Submissions Report

Dubbo Quarry Continuation Project

Prepared for Holcim (Australia) Pty Ltd
June 2021

J210189 RP#1

Figure 4.1 Model source locations – wind erosion areas – Scenario 2

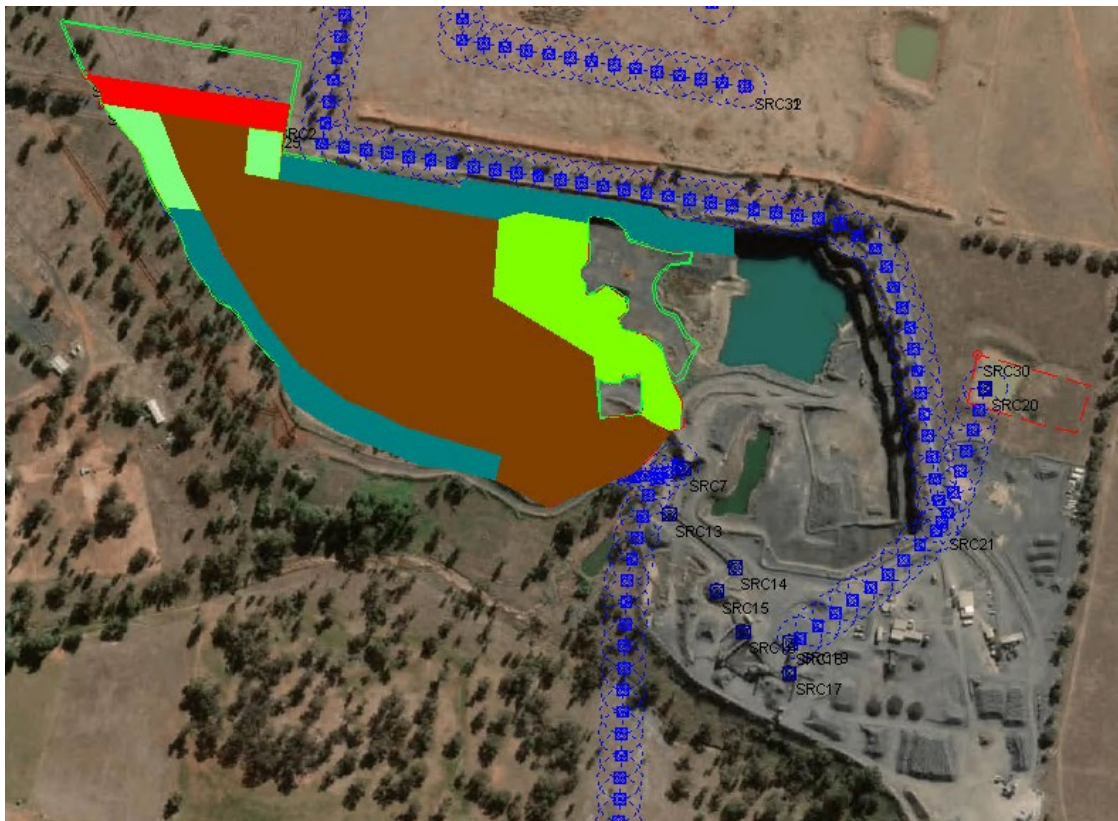
- That the AQIA should be revised to include referenced footnotes 1 and 2 for Table 6.4, Table 6.5. and Table 6.6.
- Justification for the use of line-volume sources to model the emission sources from the neighbouring South Keswick Quarry.

A control efficiency of 30% was applied to the existing area of Scenario 2 to account for the rehabilitated areas surrounding this area, shown by the dark green shaded areas in Figure 4.1. It is noted that the light green areas marked in Figure 4.1 correspond to partially rehabilitated areas and bunds (bund located to the north-west).

A modelling sensitivity test has been completed to determine the level of effect of the control used for ‘rehab bund’ on predicted concentrations. The 30% control applied for the rehab bund on the activity ‘wind erosion of existing pit exposed area’ was removed from the Scenario 2 emissions inventory.

Table 4.2 shows a comparison of the predicted incremental maximum 24-hour average and annual average PM₁₀ concentrations at each assessment location for the original assessment (‘with rehab bund controls’) and the revised modelling (‘without rehab bund controls’) respectively. The concentrations in Table 4.2 show that there is a negligible difference between the two sets of modelling results. Further, this has had no discernible effect on the cumulative results, and therefore conclusions, of the original AQIA.

Figure 5.2 2021 surveyed 15-minute peak traffic for the Sheraton Road children crossing (adjusted for actual traffic demand)

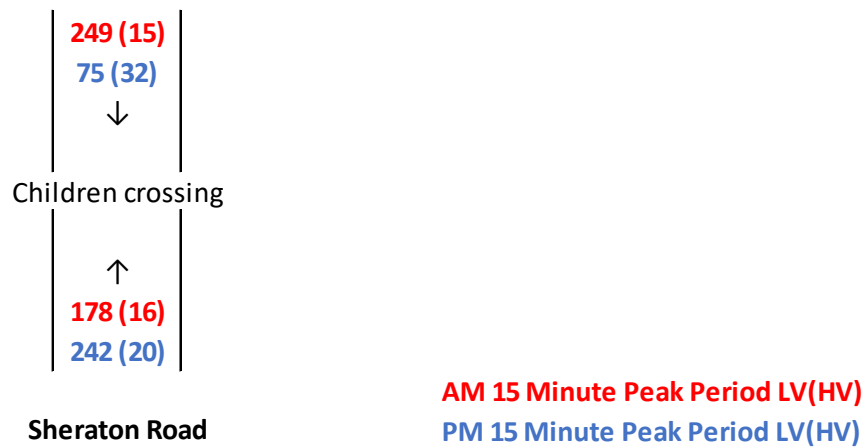
<i>95th percentile queue values modelled with SIDRA disagree with site observations, which both the submitted RSA and TfNSW staff have observed routinely approach lengths of 300 metres or more from the Mitchell Highway southwards to the supervised school crossing.</i> <i>Traffic survey is required to verify queue lengths that develop south of the roundabout, in both directions towards and away from the roundabout (noting traffic is also known to queue back toward the roundabout). The report is to explain how the SIDRA model was recalibrated to match surveyed queue lengths before updated modelling is provided.</i>	A site visit has been undertaken by EMM traffic engineers to observe queuing at the children's crossing on Sheraton Road and at the Mitchell Highway roundabout. The SIDRA model has been recalibrated to represent the observed queue lengths (see Section 5.1.)

During the 15-minute PM peak period, a queue started to build on the south approach of the children’s crossing. At the start of the peak period traffic was relatively quiet and the queue was gradually started to build up where the maximum recorded queue was approximately to 220 m. This means the recorded traffic presented in Figure 5.1 (traffic accessing the crossing) does not represent the actual traffic arrival, which includes the queued traffic on the south approach.

To represent the real traffic demand at the children’s crossing, an additional 37 cars (220 m / 6 m per car) has been added at this crossing (Figure 5.2). Traffic data shows that during the PM peak, in the 15-minute window, there are an estimated 20 northbound heavy vehicles in Sheraton Road.

Figure 5.4 2021: 15-minute peak traffic for the Mitchell Highway/Sheraton Road intersection (adjusted for actual traffic demand)

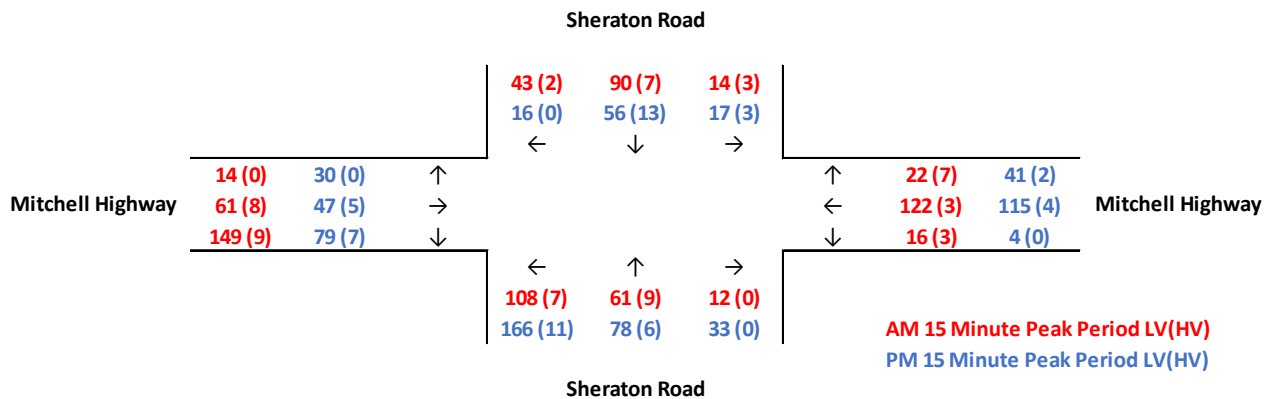
- A traffic survey is required to verify actual queue lengths on the Mitchell Highway southwards with further explanation to support the current SIDRA analysis of the roundabout of Mitchell Highway and Sheraton Road. The revised SIDRA model should incorporate the school crossing on Sheraton Road and roundabouts on Mitchell Highway to reflect real world conditions.

During the PM peak, a queue started to build on the south approach during the 15-minute peak period and the recorded maximum queue from the roundabout was approximately 530 m (ie 220 m passed the children's crossing). This means that the passing traffic presented in Figure 5.3 does not represent the actual traffic demand, which includes the queued traffic on the south approach of the roundabout.

In addition, from the site observations, critical gap and follow up headway has been increased from the default SIDRA model to 4.8 s and 2.5 s respectively to intentionally match the site observations. The SIDRA modelling results for a 15-minute PM peak period has matched the observed queue lengths on all approaches which confirms the validation of the model (see Attachment C).

Figure 10.1 2031 baseline traffic (sensitivity testing)

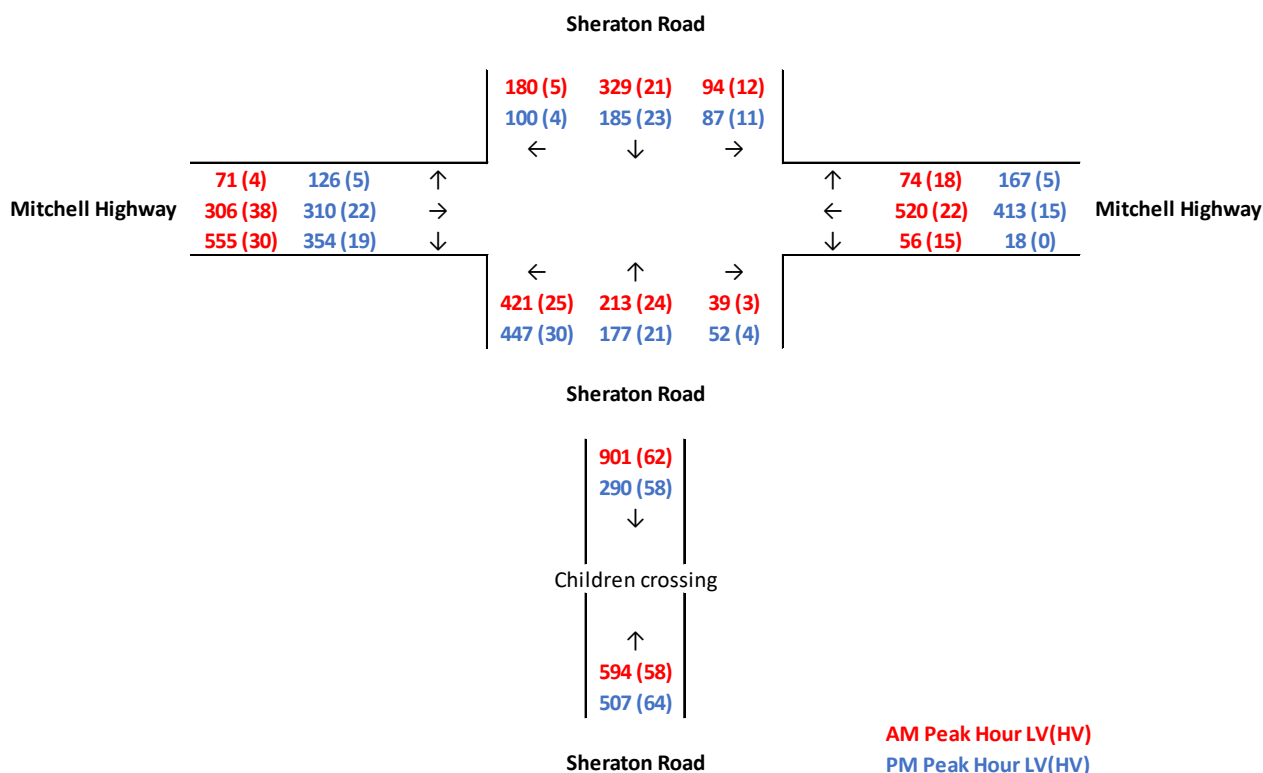
TfNSW comments	Response notes and section references
<i>The underlying assumptions used to model increases in traffic from the raw data are to be summarised. It appears the current analysis has not allowed for Skillset College or the approved increase in haulage from South Keswick Quarry, which TfNSW understands is capped at 495ktpa, 110 truckloads outbound per day and 10 loads outbound per hour.</i>	A cumulative traffic impact assessment has been undertaken (Section 8). The traffic generation from Boundary Road development, Dubbo RSL and South Keswick Quarry have been discussed and agreed with both TfNSW and Dubbo Regional Council before any modelling work. The Skillset College has start and end times outside of our assessed peak hours therefore its associated movements would not need to be captured. Hence, the cumulative traffic impact assessment has been done as per agency agreements.
<i>The neighbouring quarry (DA2016/482) committed to limit maximum hourly traffic to 20 hourly movements (in and out combined), equating to a peak factor of around twice the average number of loads required to achieve approximately 500ktpa. This approach is commonly taken on similar developments. Higher peak traffic volumes are associated with poor safety and efficiency outcomes, especially where they coincide with elevated background traffic. The applicant should consider an appropriate reduced hourly limit or is to justify why the current proposed limit is necessary.</i>	Dubbo Quarry operates differently to the neighbouring South Keswick Quarry as they serve different customers with different truck sizes. Holcim sells/delivers, on average, 33 tonne of product per truck with smaller trucks often visiting the site to purchase product ad hoc. It is understood that South Keswick Quarry typically delivers 39 tonne of product in its trucks and does not have ad hoc sales. The Dubbo Quarry also has shorter proposed haulage hours over the day where product can be sold or delivered compared to South Keswick Quarry. These factors allow for South Keswick Quarry to reduce their hourly truck numbers whilst still achieving the same annual production volume as Dubbo Quarry. The two quarries have comparable maximum daily truck movements, 242 for Dubbo Quarry and 220 for South Keswick Quarry, with the difference attributed to smaller truck sizes frequenting the former. Further, it should be noted that these maximum volumes are expected to occur infrequently and would not be a regular occurrence. They have been presented to assess a potential worst case impact scenario as is standard practice for undertaking comprehensive traffic impact assessments.

As requested by TfNSW, an additional sensitivity testing has been undertaken with 1.8% linear annual growth factor on both Mitchell Highway and Sheraton Road in 2031. Figure 10.1 presents the 2031 baseline traffic with 1.8% linear annual growth factor on all roads.
